Lower Thames Crossing 9.8 Environmental Statement Addendum (Tracked changes version)

DATE: December 2023

Planning Inspectorate Scheme Ref: TR010032
Examination Document Ref: TR010032/EXAM/9.8

Page number
Figure 1 ES Addendum update to information in figures and plates	296
Figure 2 Shorne and Ashenbank Woods SSSI boundary update	296

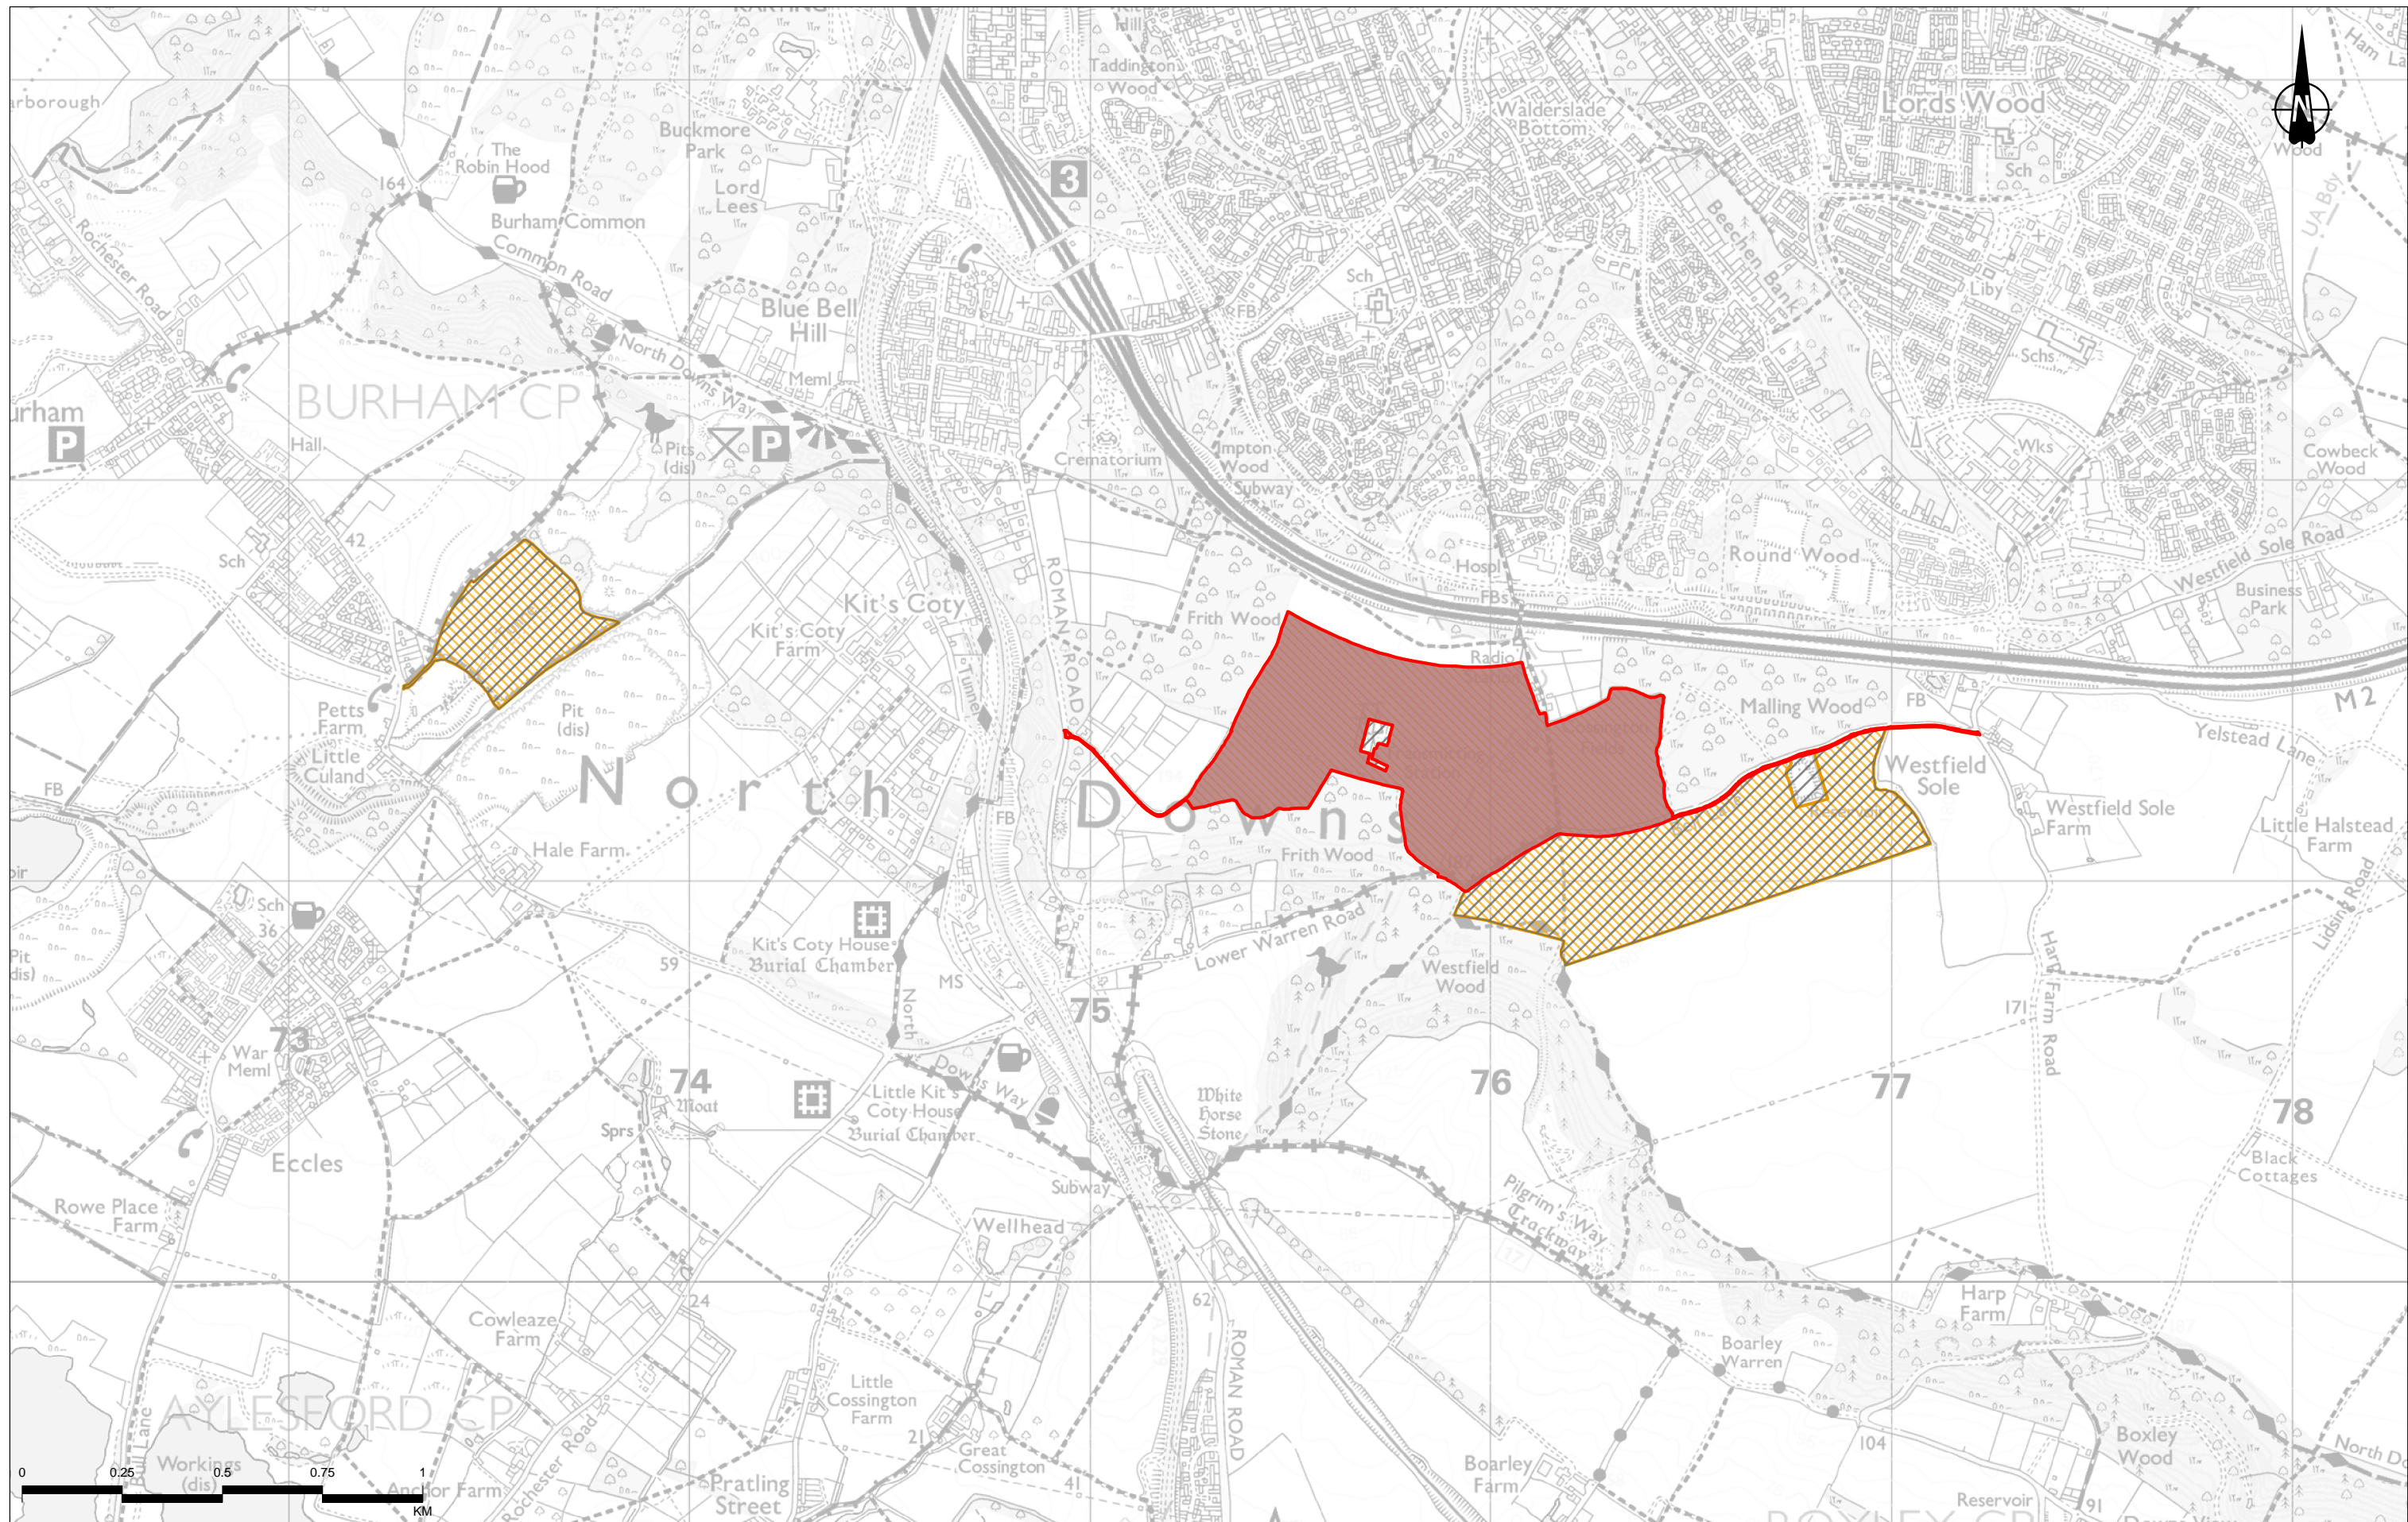
updates to nitrogen deposition compensation areas have been updated by the issue of a new version of the document, but are updated by reference to Figure 1, included in this ES Addendum. This shows the original nitrogen deposition compensation proposals and the final nitrogen deposition compensation areas as presented at Deadline 9. All figures and plates updated via the ES Addendum should be read with reference to Figure 1, Figure 1.

Similar to above, Figure 1, also shows the original and revised locations of the Muckingford Road and Low Street Lane Utility Logistics Hubs (ULH 11 and 12 respectively). As for the above, the record of updates in Section 3 identifies where documents containing this information should be read with reference to 4.1.1 Figure 1.

Plate A.1 Site boundary and condition status for Shorne and Ashenbank Woods SSSI¹

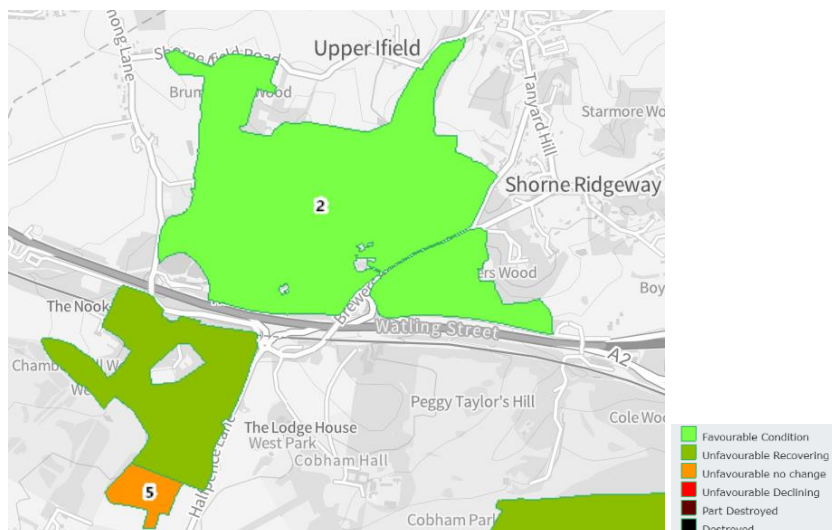
A.2.2 The boundary for the SSSI is shown in Plate A.1, together with current status. The status of each of the three areas shown on the figure has been updated at different times. The figure shows that the areas of the SSSI to the north of the A2 (classified as Randall Wood and Brewers Wood) are in favourable condition (these areas were last surveyed / updated in 2010 according to Natural England data accessed online; prior to this survey, both Randall Wood and Brewers Wood were categorised as 'unfavourable recovering' in 2005). To the south of the A2, the majority of the SSSI (classified as Ashenbank Wood) has been categorised as 'unfavourable recovering' (last surveyed / updated in 2016, with no change in category since the previous survey undertaken in 2008). A small portion of the designation to the south of the A2 (Ashenbank Wood – south) is categorised as 'unfavourable no change' (the only survey recorded took place in 2008).
